Flatted Residential Development, With Associated Car Parking, Amenity Space and Landscaping

Site of Wallace Craigie Works
2 Broughty Ferry Road
Dundee

**Report by Head of Planning
& Economic Development**

SUMMARY OF REPORT

Figure 4 – Proposed Site Plan

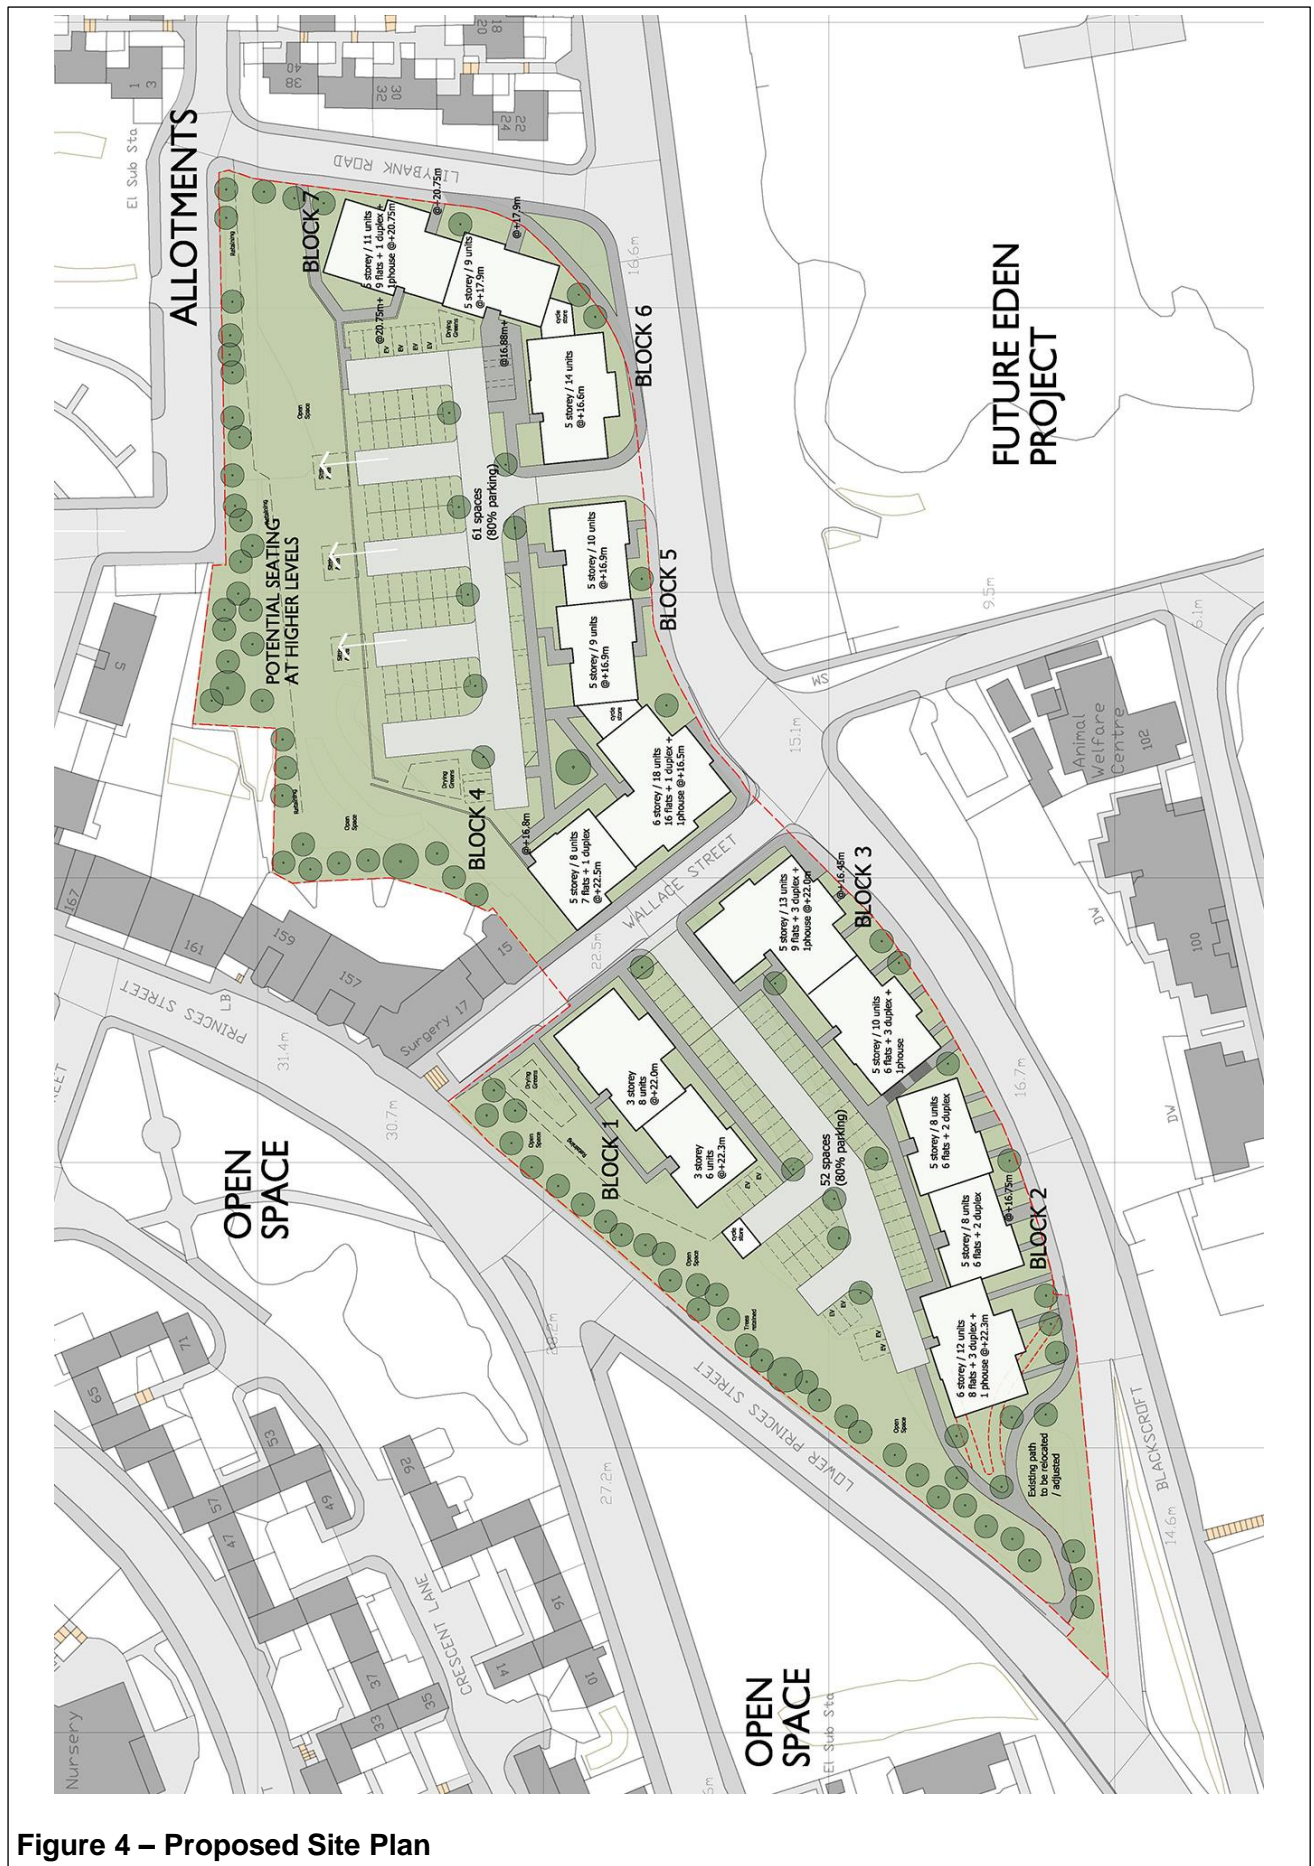
- 7.53 With regard to the character and amenity of Broughty Ferry Road and surrounding streets, existing development includes a mixture of houses and flatted dwellings within buildings between two and four storeys in height. The proposed buildings vary between 5 and 6 storeys and are therefore of a scale and massing which is greater than surrounding development. Due to the significant change in levels along the western part of Blackscroft, the proposed development would sit prominently on the skyline when viewed from the south. There are multi-storey buildings in the surrounding area. However, the proposed buildings fronting onto Broughty Ferry Road would be up to 6 storeys in height. This is greater than surrounding developments and would introduce buildings of significant massing to the north side of

Broughty Ferry Road and this would appear out of context with the character of the surrounding area. The provision of recessed elements and balconies on the south elevation of the buildings does provide visual interest. However, the buildings would not integrate sensitively with the existing streetscape. The buildings do not align with the site's south boundary and do not form a coherent frontage along Broughty Ferry Road. The scale of the buildings and small set back from Broughty Ferry Road does not contribute to the overall appearance of the development, and the open spaces created are small in scale and of low quality being subject of direct overlooking and traffic noise. Overall, the form and density of the proposed buildings has not been carefully considered and fails to respect the character of the surrounding area.

7.147 Amenity/Garden Ground – The proposed development would require a minimum of 1,440 sqm of useable private communal garden ground. Useable private communal amenity/garden ground of 1120 sqm would be provided, with three separate drying areas. There are areas of open space proposed within the site. However, these would not be useable as they would contain planting; are steeply sloping in nature; and are some distance from the flats. It is proposed that 85 of the properties would include balconies with attractive outlooks to the south. However, they are of a small scale varying from 4m² to 10m² which would provide limited useable outdoor space in addition to the communal garden ground. Overall, the proposal fails to provide a minimum of 1,440m² of useable private communal garden ground or useable amenity spaces. This standard is not met.
